City of Mississauga

City Department and Agency Comments

Date Finalized: 2021-05-05	File(s): A460.19 Ward: 1
To: Committee of Adjustment	
From: Committee of Adjustment Coordinator	Meeting date:2021-05-13 1:00 PM

Property Address: 1499 Trotwood Avenue

Appendix 1 – Transportation and Works Comments

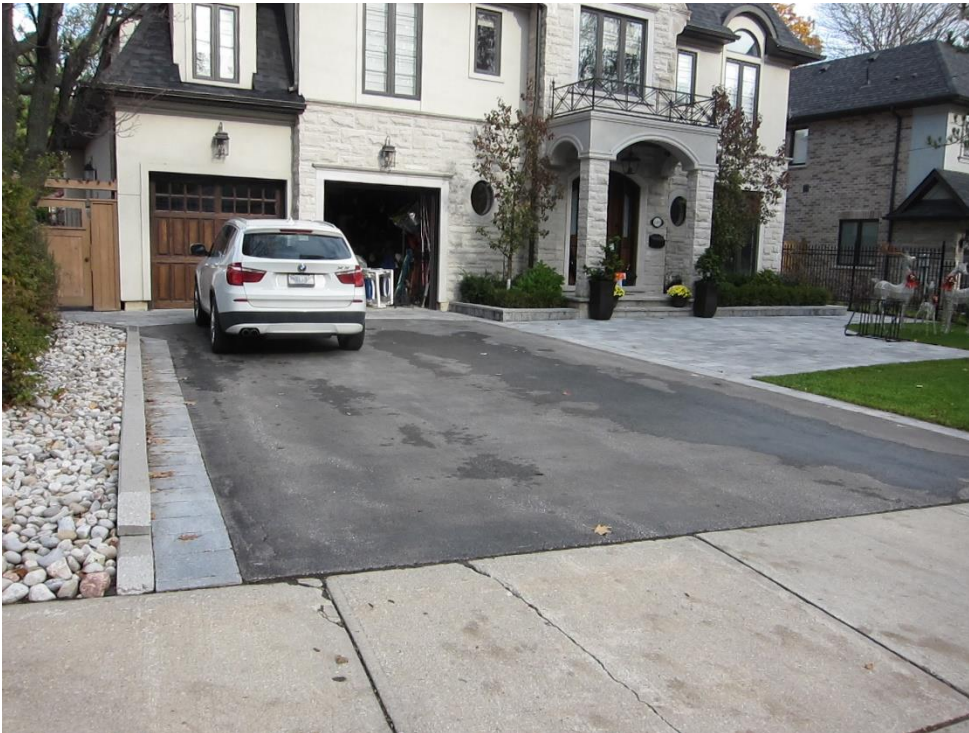
Enclosed for Committee's easy reference are photos depicting the existing driveway configuration on site.
